Model: LCIT RT5060 (D516)	Date: 20-Jun-11	No.: RD516001
---------------------------	-----------------	---------------

Subject: Firmware Release Note: LCIT RT5060		Prepared by: K.Tsutsui	
From: PPBG Service Planning Dept.			
Classification:	<input type="checkbox"/> Troubleshooting <input type="checkbox"/> Mechanical <input type="checkbox"/> Paper path <input type="checkbox"/> Product Safety	<input type="checkbox"/> Part information <input type="checkbox"/> Electrical <input type="checkbox"/> Transmit/receive <input checked="" type="checkbox"/> Other (Firmware)	<input type="checkbox"/> Action required <input type="checkbox"/> Service manual revision <input type="checkbox"/> Retrofit information <input checked="" type="checkbox"/> Tier 2

Model: Aegis-C1 (D016)		Date: 23-Jan-12	No.: RD016018
Subject: Part Changes; Handle assembly and Shoe		Prepared by: A. Takada	
From: PP Tech Service Dept., 1st PP Tech Service Sect.			
Classification:	<input type="checkbox"/> Troubleshooting <input type="checkbox"/> Mechanical <input type="checkbox"/> Paper path <input type="checkbox"/> Product Safety	<input checked="" type="checkbox"/> Part information <input type="checkbox"/> Electrical <input typ

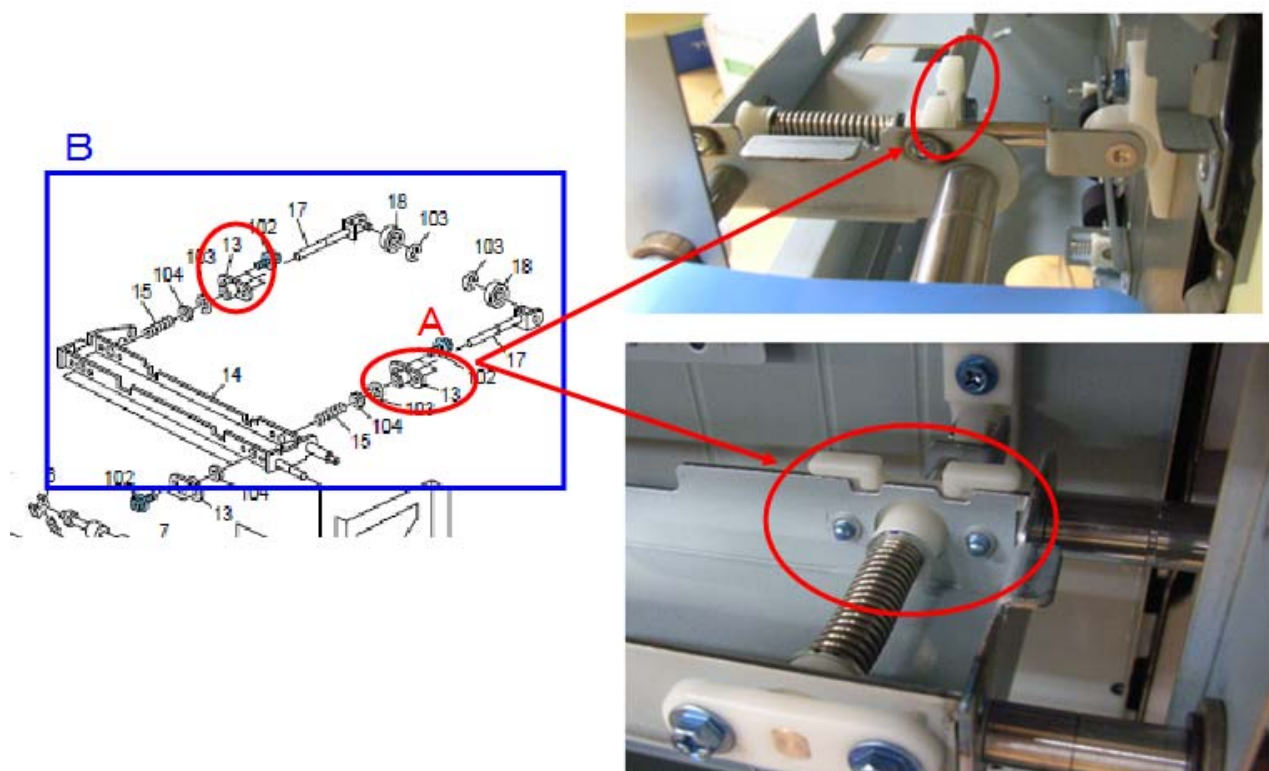
**Change:** Shape of the Handle assembly and Shoe

**Reason:** To enable usage of common parts with different products

A : Shoe: Handle: Release

Shape of the Shoe was partially modified.

B : Handle: Ass'y

Handle was also modified in accordance with the shape change of the Shoe.  
(Shape of the plate was also modified.)

## Model : Aegis-C1 (D016)

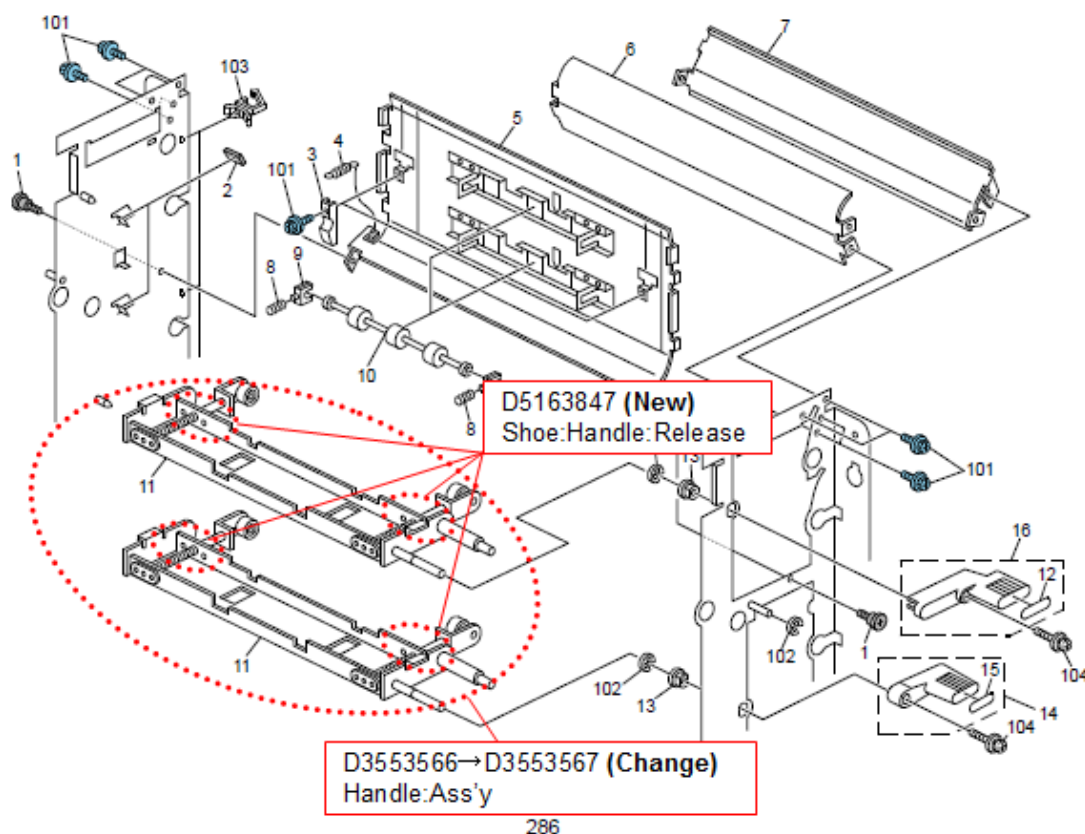
Old Part Number	New Part Number	Description	Q'ty	Int	Page	Index	Note
D3553566	D3553567	Handle:Ass'y	2	X/O	287	11	-
-	D5163847	Shoe:Handle:Release	4		287	17	-

- If the unit is now installed with D3553566, replace with D3553567. D5163847 is not needed.
- D5163847 can be attached ONLY to D3553567.
- The modification described in this bulletin also applies to Aries C-1.5 (D095), LCT RT5020 (D355), LCIT RT5050 (D532), and LCIT RT5060 (D516).

## Main Frame (D516)

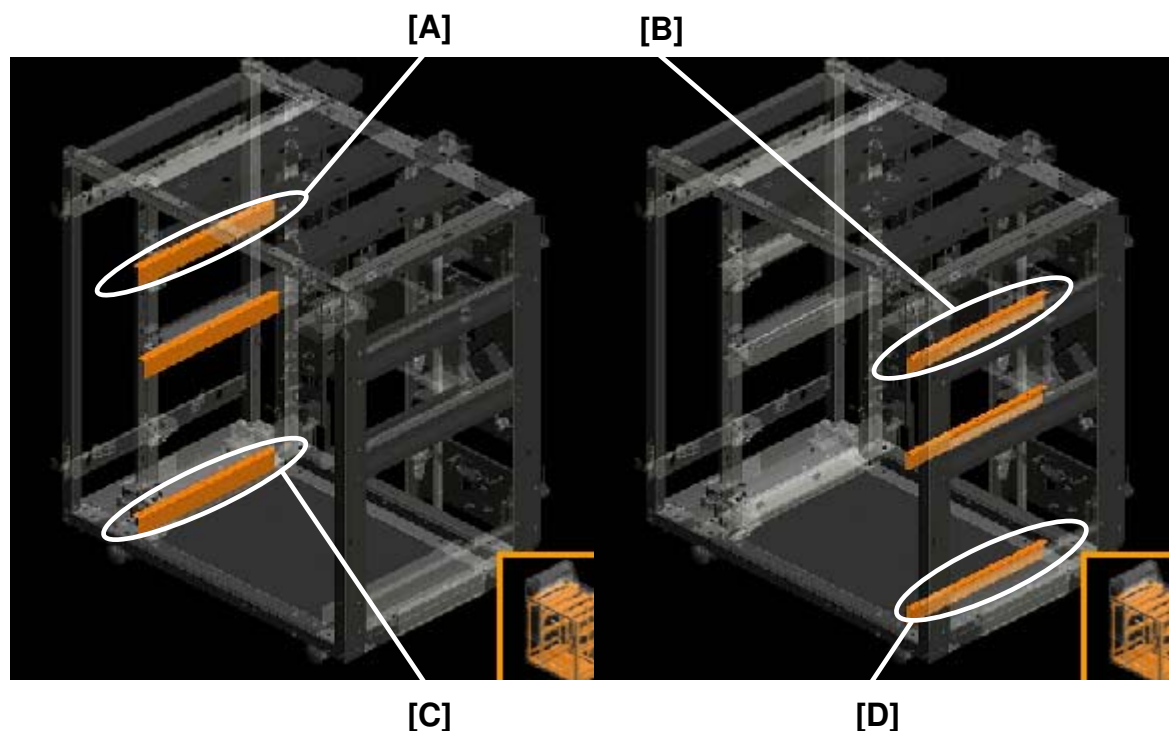
Old Part Number	New Part Number	Description	Q'ty	Int	Page	Index	Note
D5161145	D5161125	SLIDE RAIL:LEFT:1K:ASS'Y	2	O / O As a set		-	
D5161155	D5161135	SLIDE RAIL:RIGHT:1K:ASS'Y	2			-

The part numbers of the rails for the 1k trays (Trays 3 and 5) have changed. Part number of the rails for the 2k tray (Tray 4) remains the same.

Rails for both sides of the tray must be replaced as a set. Replace [A] & [B] as a set, and [C] & [D] as a set.
